**MEETING AGENDA**  
**PUBLIC WORKS SUBCOMMITTEE**  
April 8<sup>th</sup>, 2024 at 01:00 pm CT

**Item 2.** East Bridge Replacements – 43<sup>rd</sup> Street NW Box Culvert Review

## TECHNICAL MEMORANDUM

**Re:** **McKenzie County – 43<sup>rd</sup> Street NW Box Culvert Review**

Figure 3  
**PRE- & POST-PROJECT INUNDATION**

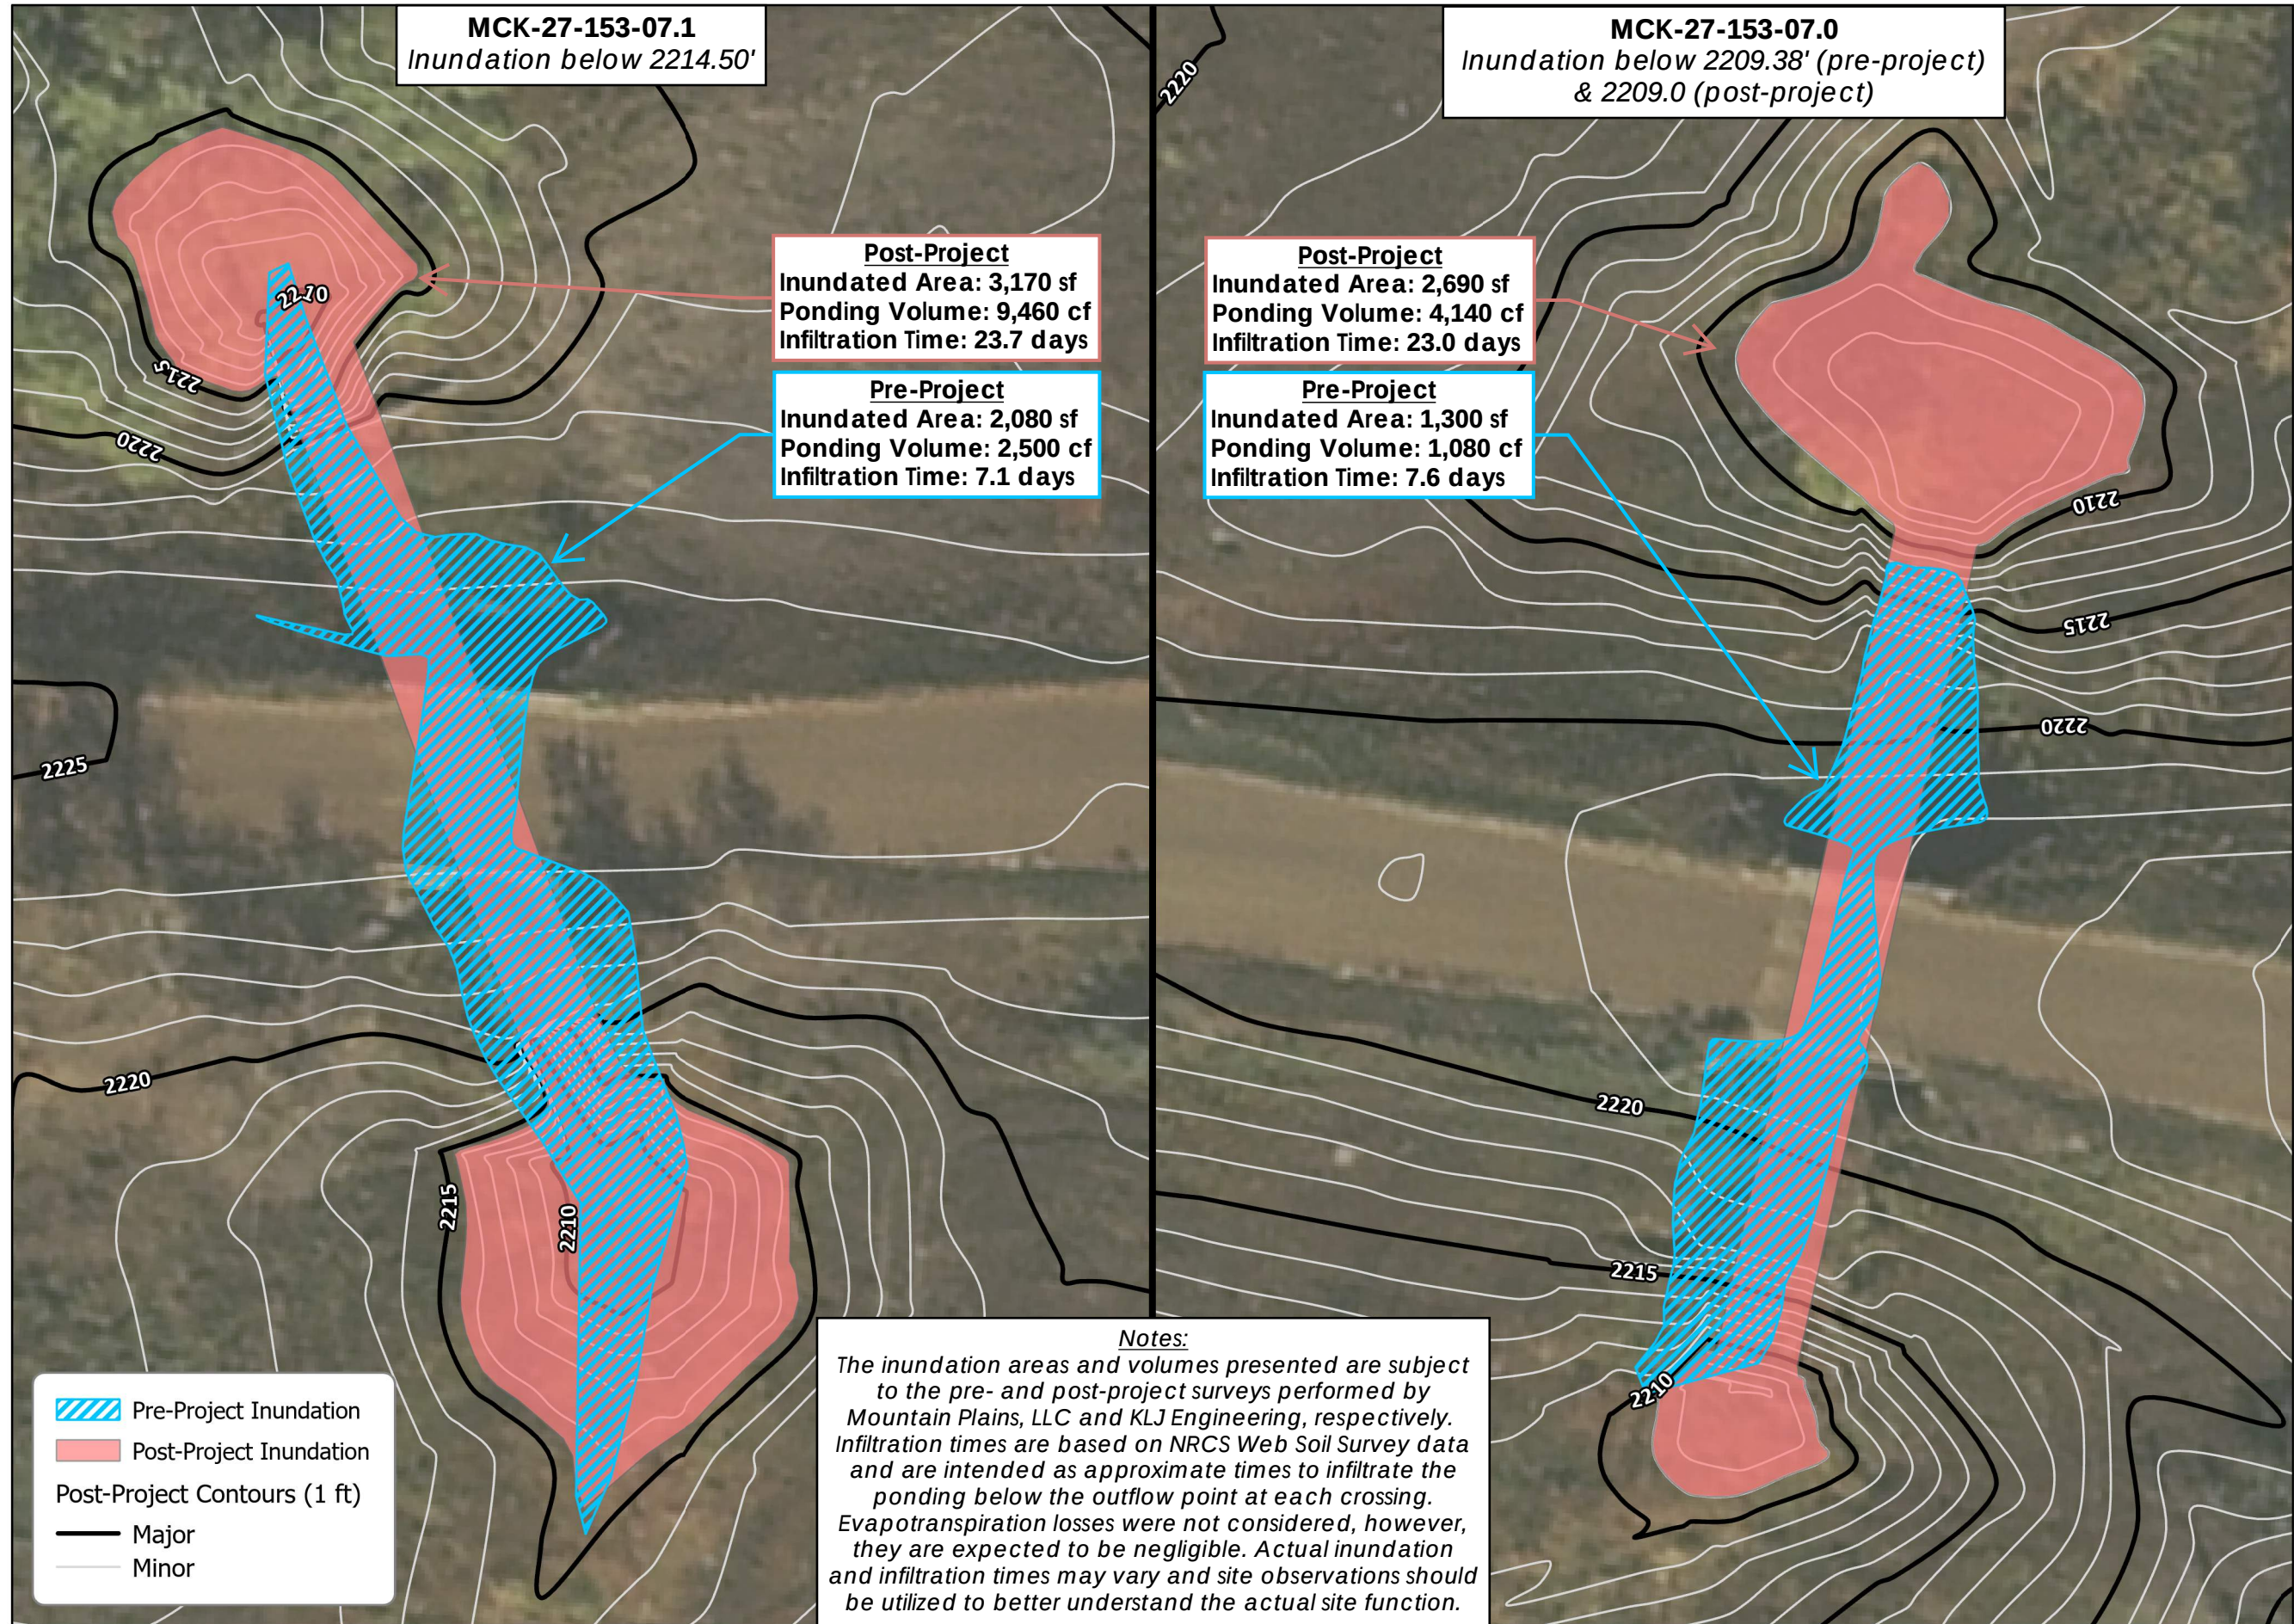
### **Increased Inundation:**

Based on the analyses performed, the constructed crossings likely result in minor headwater increases compared to the pre-project conditions with additional increases as sedimentation occurs within the crossings or during periods of ice accumulation. An access road located north of 43<sup>rd</sup> Street NW and east of crossing 07.1 appears to be susceptible to inundation when headwater elevations at crossing 07.1 are above ~2,222' and a residence on the north side of 43<sup>rd</sup> Street, between the two crossings, appears to be susceptible to impacts when water surface elevations exceed about 2,223.5'. Increased inundation resulting at these crossings is likely to be of relatively short duration. Any changes made to the crossings that could increase inundation should first be coordinated with the impacted property owners.

Figure 4 Crossing 07.1 Stream Profile and Grading Concept

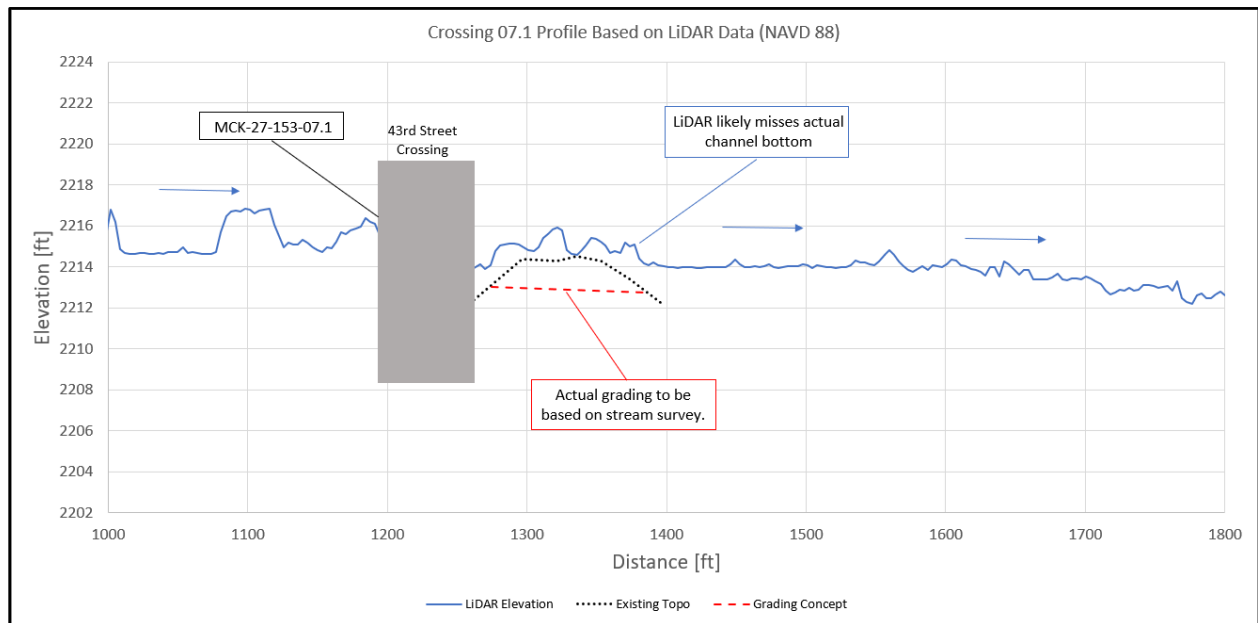
The pre-project high point of ~2,214.5 downstream of crossing 07.1 appears to remain in the post-project conditions and may be able to be lowered to approximately 2,213' (see **Figure 4**). These estimates are based on the limited pre-project topographic survey by Mountain Plains, LLC. Prior to pursuing a grading project, a stream profile survey should be performed to better understand the stream profile and to ensure a grading project would provide desirable results.

Channel grading may impact regulatory wetlands and be subject to Section 404 permitting through the U.S. Army Corps of Engineers (USACE) which may subject a grading project to certain limitations. 404 permitting implications should be considered prior to and during a design project and the permit must be obtained prior to proceeding with construction.

Figure 5  
**RECOMMENDATION  
OVERVIEW**

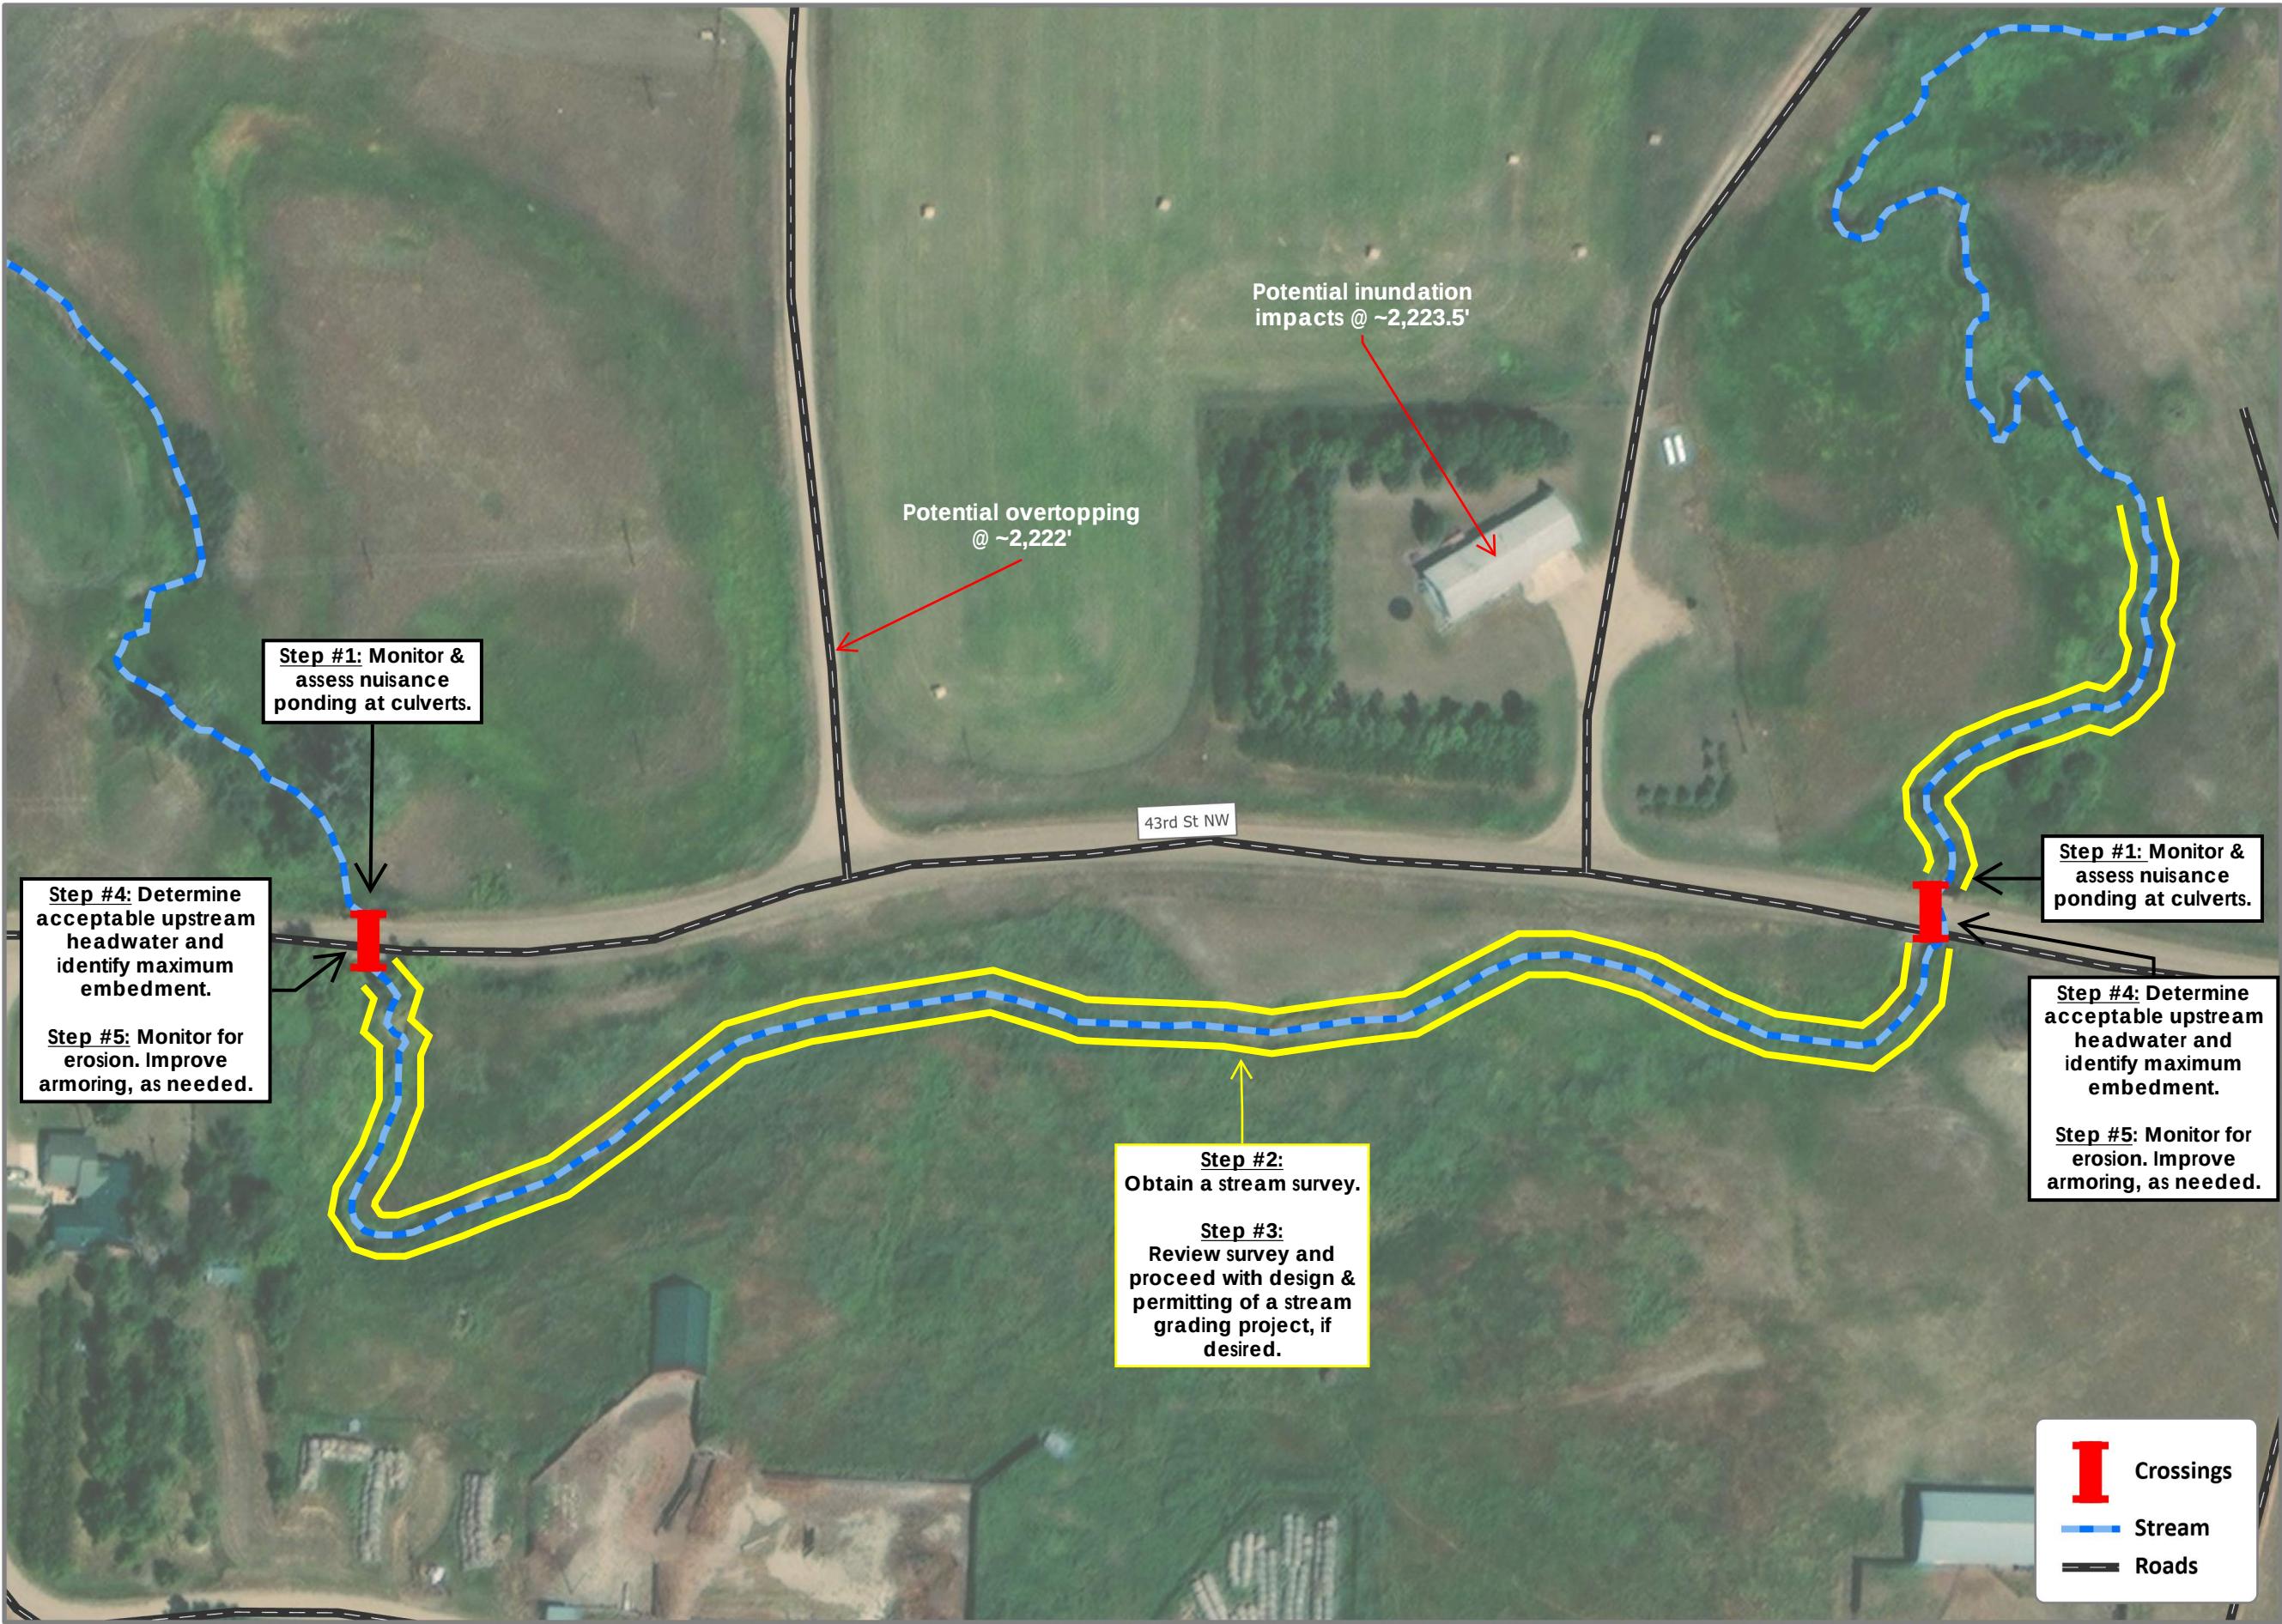
Resetting, replacing, or adding culverts to the constructed crossings are options, however, due to the likely expense and challenges associated with those options, an alternative approach is recommended below and summarized in **Figure 5** at the end of this section.

**Step #1:** Monitor the crossings for nuisance ponding and ice accumulations following the monitoring and inspection plan below. An inspection log is provided in Appendix 1.

**Step #2:** Obtain a stream survey of the channel thalweg between crossing 07.1 and 07.0 as well as ~350 feet downstream of crossing 07.0. Use the survey information to verify whether the outflow elevations at the crossings can be effectively lowered with localized channel grading.

**Step #3:** If stream survey verifies that ponding reductions could be achieved at one or both crossings, update the hydraulic analysis accordingly, and proceed with design and permitting of channel grading improvements, if desired.

**Step #4:** Determine acceptable upstream headwater elevations and identify the maximum embedment depth that, in conjunction with the grading potential identified in Steps #2 & #3, can be implemented without exceeding the acceptable headwater elevations. If the grading potential identified in step 3 is similar to the assumptions discussed in Mitigation Option #1, **Table 8** may be referenced to identify acceptable embedment depths.

**Step #5:** If modifications are constructed, or if erosion occurs downstream of crossings, install rip rap armoring downstream of each crossing based on HEC-14 criteria to reduce risk of erosion at the pipe outfalls.
